Informal document **WP.29-158-22**  
(158<sup>th</sup> WP.29, 13-16 November 2012,  
agenda item 4.13.3)

**Proposal for corrections to ECE/TRANS/WP.29/2012/53  
(GRSP) Proposal for a new Regulation on Child Restraints  
Systems**

The text reproduced below was drafted by the chairman of the IWG CRS

Figure of paragraph 4.5., replace by the following figure:

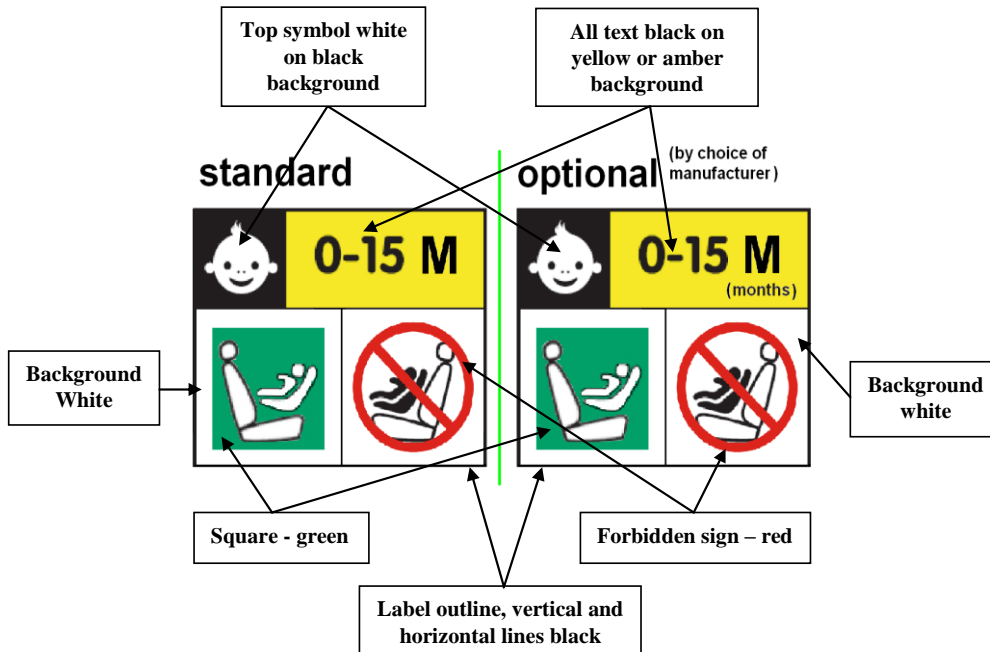
“Minimum label size 40 x 40 mm

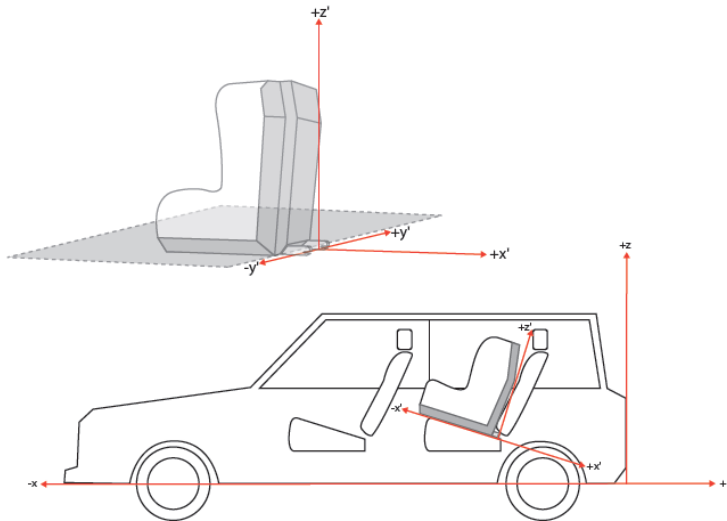
Paragraph 6.3.5., amend to read:

- 6.3.5. i-Size Child Restraint System support-leg and support-leg foot requirements
- i-Size Child restraint systems fitted with support-legs must comply in all positions of use (e.g. in case of length adjustable attachment, base, etc. the shortest and longest position) with the geometrical provisions defined in 6.3.5. and its subparagraphs.

- Compliance with the requirements specified in paragraphs 6.3.5.1. and 6.3.5.2. may be verified by a physical or computer simulation.
- The geometrical requirements in paragraphs 6.3.5.1. to 6.3.5.4. are referenced to a coordinate system, whose origin is located centrally between the two ISOFIX attachments and on the centreline of the corresponding ISOFIX anchorage system.

- The orientation of the axes of the coordinate system is referenced to the child restraint fixture(s):
- (a) The  $X_z$  axis shall be parallel to the Child Restraint Fixture (CRF)<sup>1</sup> bottom surface and in the median longitudinal plane of the CRF;

- (b) The  $Y'_z$  axis shall be perpendicular to the median longitudinal plane;
- (c) The  $Z'_z$  axis shall be perpendicular to the CRF bottom surface.

Figure 1

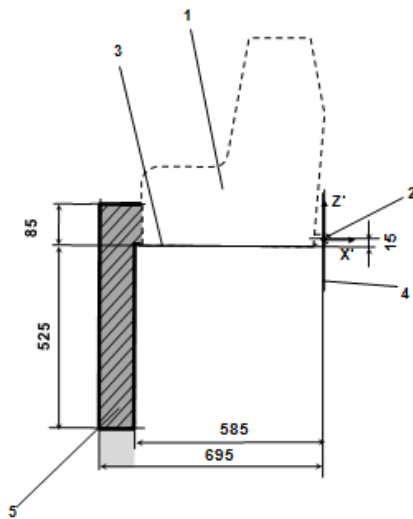
Annex 19, figure 1 to figure 3., amend to read :

Side view of the support leg dimension assessment volume

~~2. Volumes (5 and 6) are defining the maximum limits of the support leg and its foot. No parts of the CRS shall exceed these limits in any position of adjustment when in use configuration.~~

Figure 2

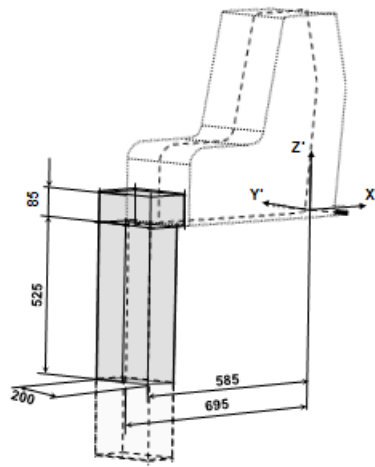
**3D view of the support leg dimension assessment volume**

Figure 3  
Side view of the support leg foot assessment volume

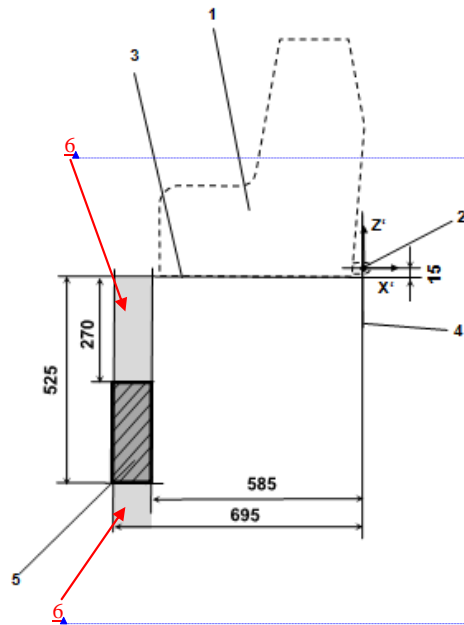
1. Child Restraint Fixture (CRF)
2. ISOFIX low anchorages bar
3. Plane formed by the bottom surface of the CRF, which is parallel to and 15 mm below the X-Y plane of the coordinate system
4. Z-Y plane of the coordinate system
5. Support-leg foot assessment volume, which shows the required adjustment range of the support-leg foot in Z directions, as well as the dimensional limitations in X and Y direction
6. Additional volumes shows the additional permissible adjustment range in Z direction for the support-leg foot
